DECLARATION OF CHANGES

Type of equipment: **Bluetooth headset**

Model: **Neo-507**

FCC ID: **RGPCAPR**

CHANGE IN THE POWER SUPPLY

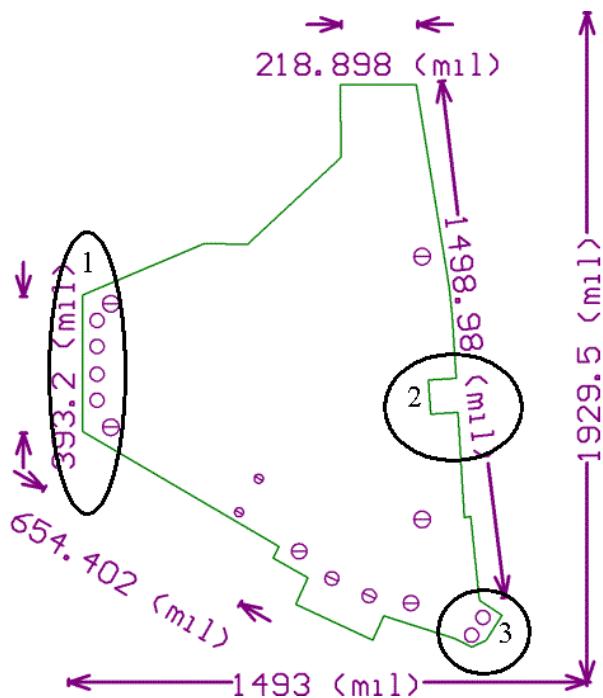
The equipment is distributed with two new AC/DC power adaptors.

CHANGES IN THE PCB OUTLINE

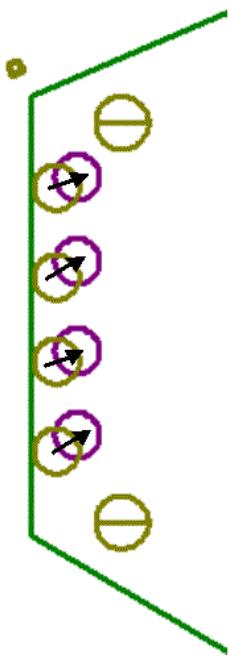
- Slight changes in the PCB outline to accommodate the new plastic cover and new power supply adaptor:

- PCB edge moved 0.8mm towards the center

- Battery and Speaker holes moved
